Peer Review of the Watershed Assessment Model (WAM)

Final Panel Report

April 6, 2009

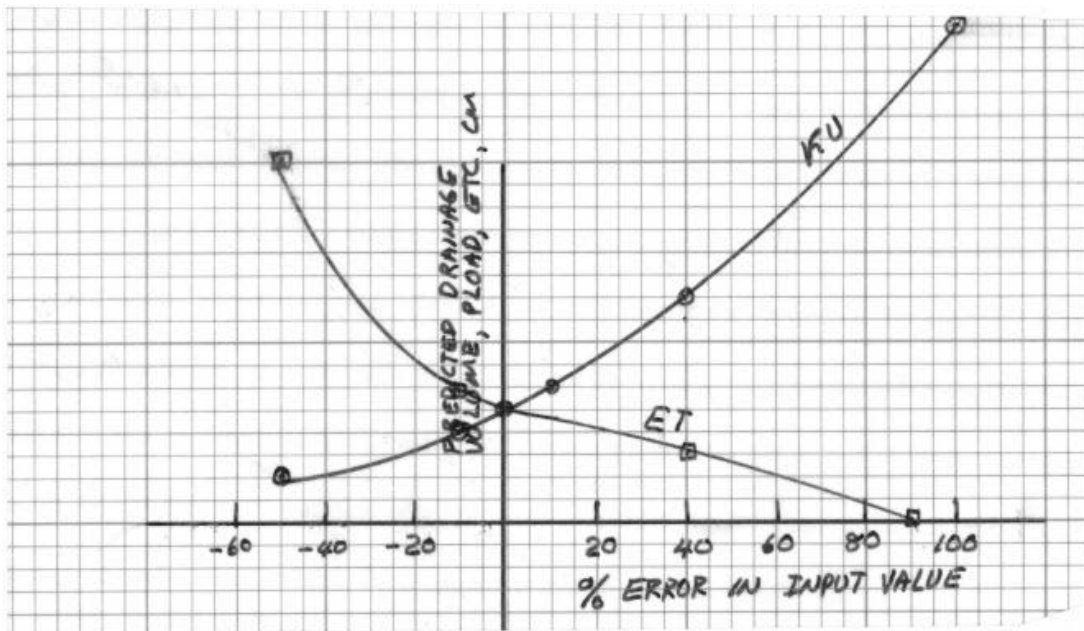
The basic strategy of determining the sensitivity of the model by changing a single input, while holding the others constant, and determining the effect on the model predictions, is appropriate and needed. Reporting the results in terms of a sensitivity ratio is efficient, in that only a few numbers have to be tabulated or plotted. However, this presents the results in an abstract form that is hard to interpret. For one thing the dependent variable is not identified; e.g. for the hydraulic sensitivity analysis given in Figures 1 and 2, what is the dependent variable? Total subsurface drainage outflow for the 2.5 years? Annual surface + subsurface outflow? There are results given for inflow and outflow. What is inflow? Subirrigation into the profile? The physical situation that was modeled (i.e. a field with an adjacent ditch connected to a farm ditch via a culvert) for the sensitivity analysis is not adequately described. A sketch would help here. The input parameters that were tested for hydraulic sensitivity are not clearly defined. For example, what is **K-imp**? I assume this is K in the lower layer (below the restrictive or marl layer), but it isn't defined that way in the text. **Soil def** must be soil moisture deficit, but its

meaning is not clear, as it hasn't been defined. These issues are easy to clear up and should be

addressed.
